LONG-TERM MANAGEMENT PLAN NORTHEAST CAPE FUDS

ST. LAWRENCE ISLAND, ALASKA

**Formerly Used Defense Site Nos.
F10AK0969-03 and F10AK0969-05**

**FINAL
SEPTEMBER 2016**

NORTHEAST CAPE SITE 28 - DRAINAGE AND EXCAVATIONS			
NORTHEAST CAPE, SAINT LAWRENCE ISLAND, ALASKA			
JACOBS	DATE: 15 JUN 2016	PROJECT MANAGER: K. MAHER	FIGURE NO: A-8

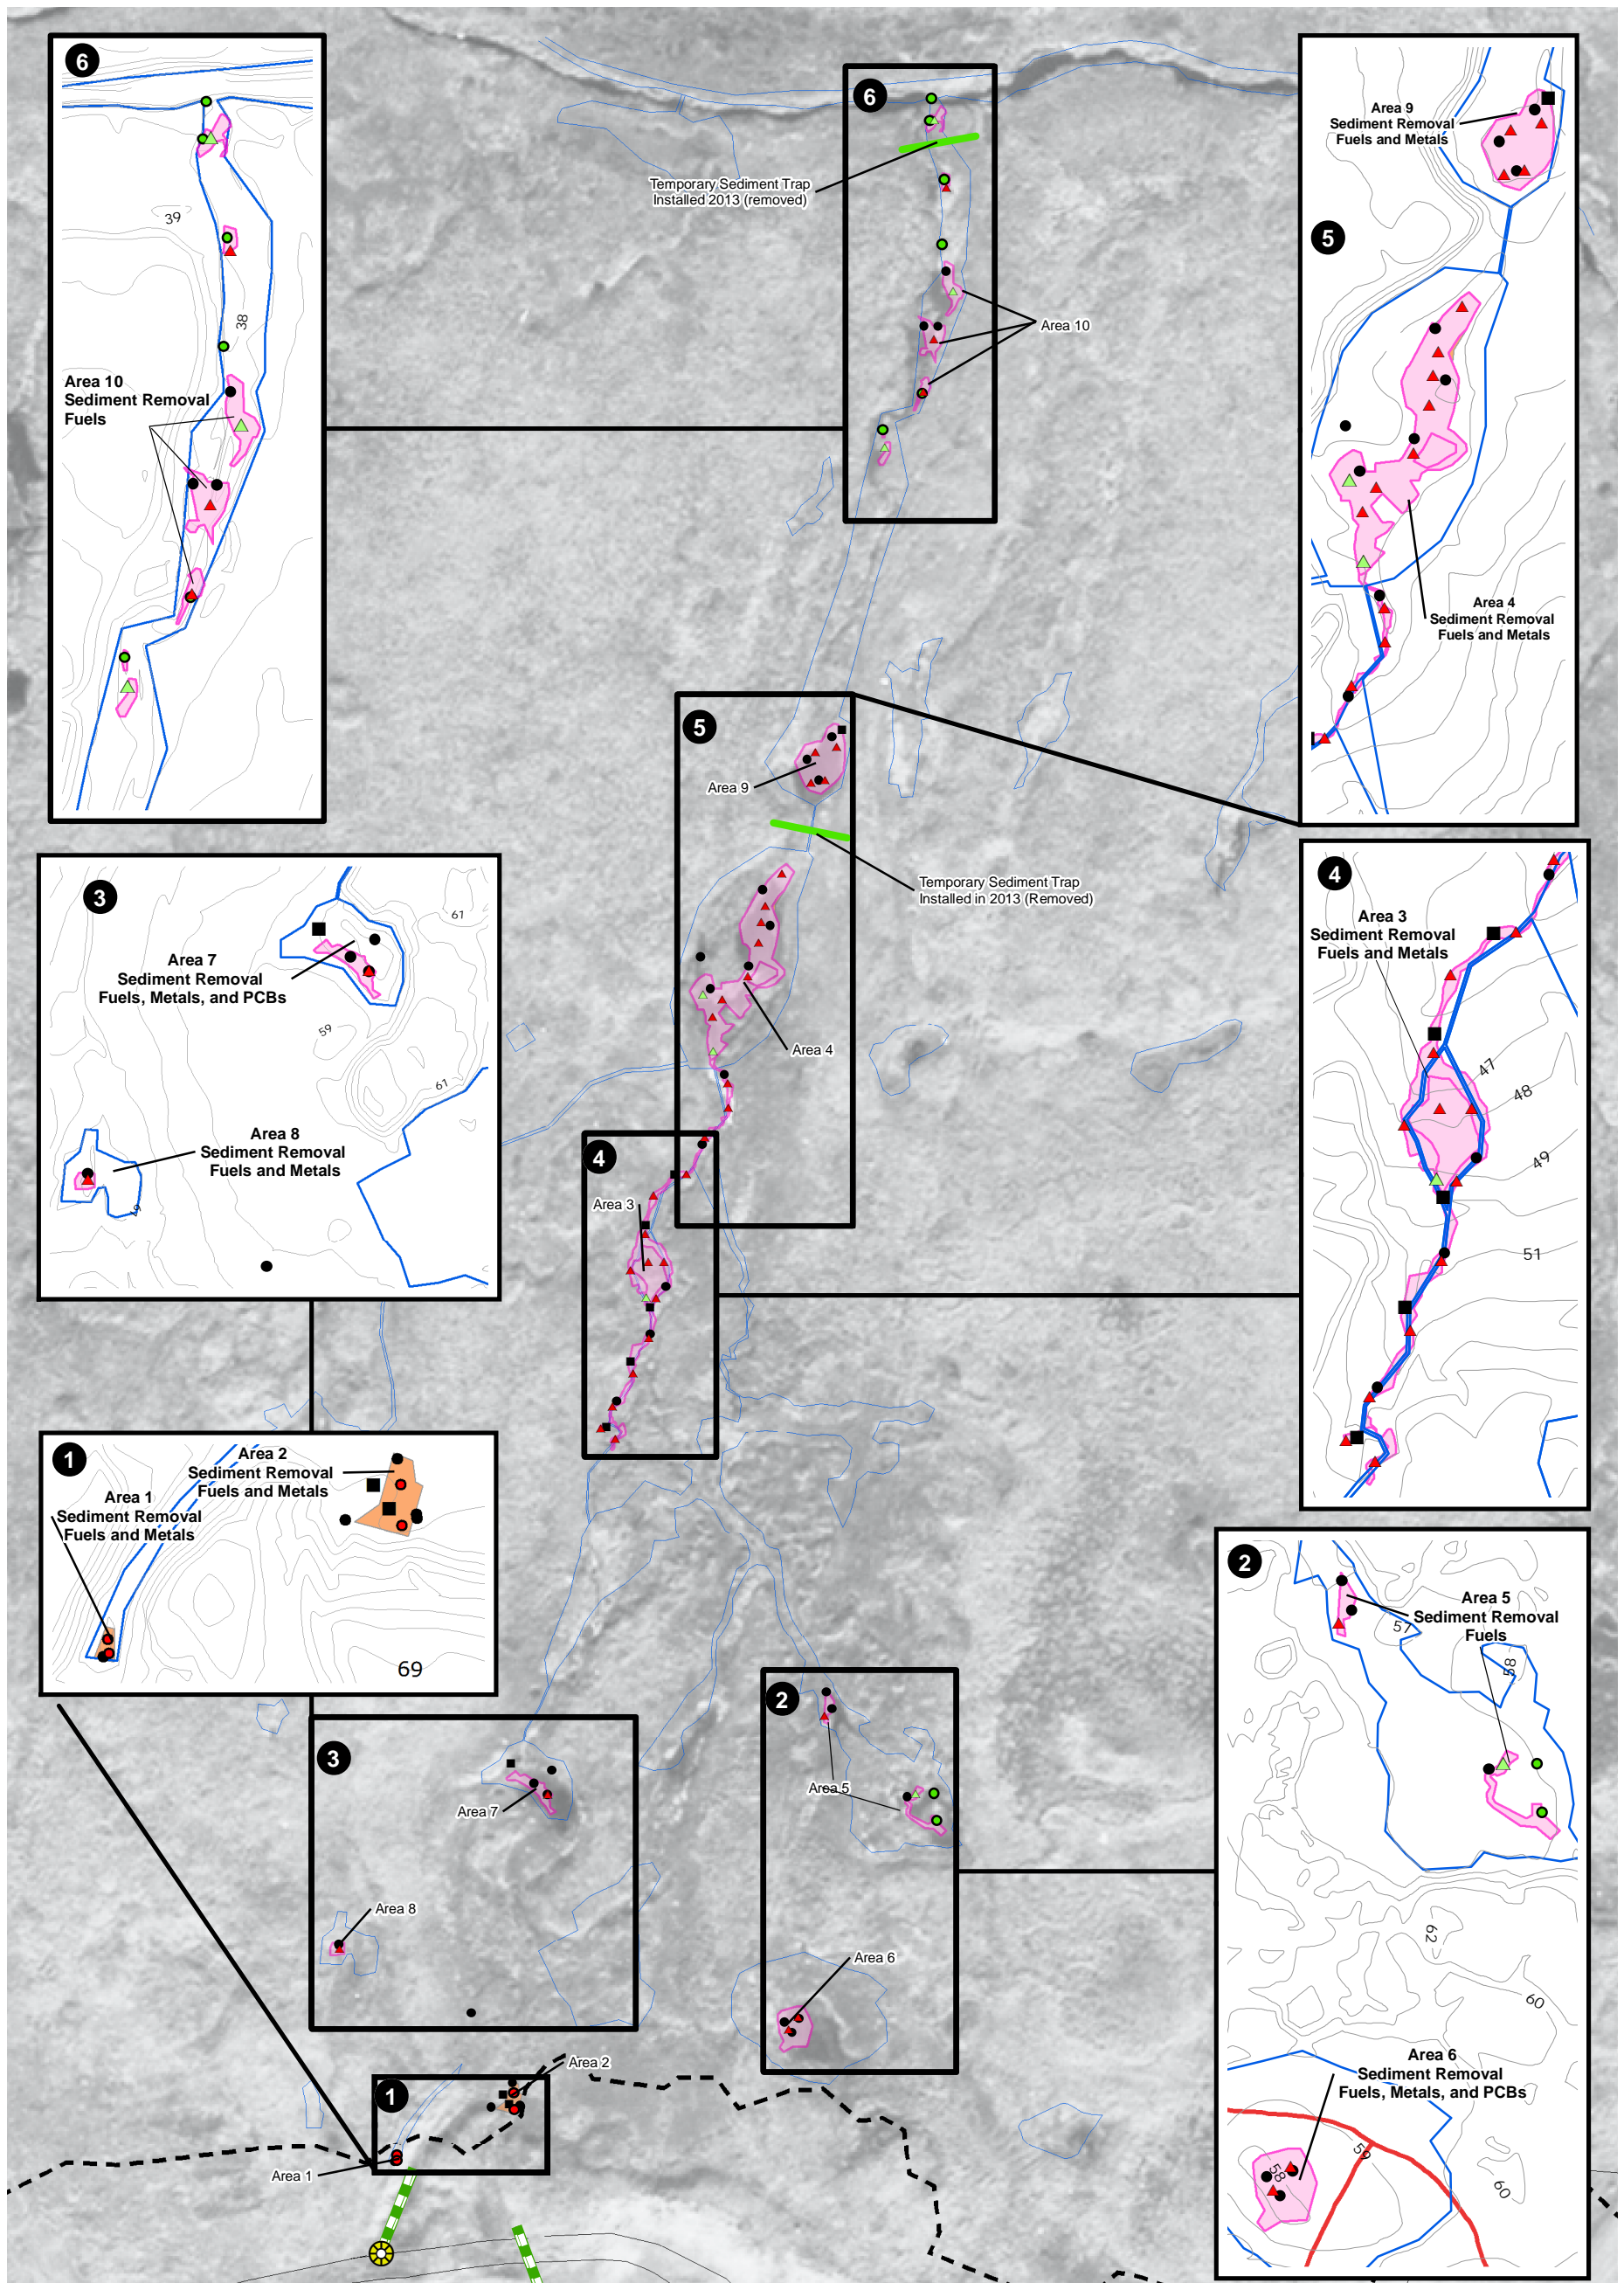
65.		Figure A-8	Please clarify the 2013 soil confirmation sample locations which are stated in the legend as having exceeded cleanup levels; whether or not contamination at these locations was removed.	Accepted. Figure will be revised to remove soil confirmation sample locations associated with Main Operations Complex excavations. Figure A-6 will be revised to show soil confirmation sample locations exceeding cleanup levels that remain in place. ADEC- Accepted August 24, 2016
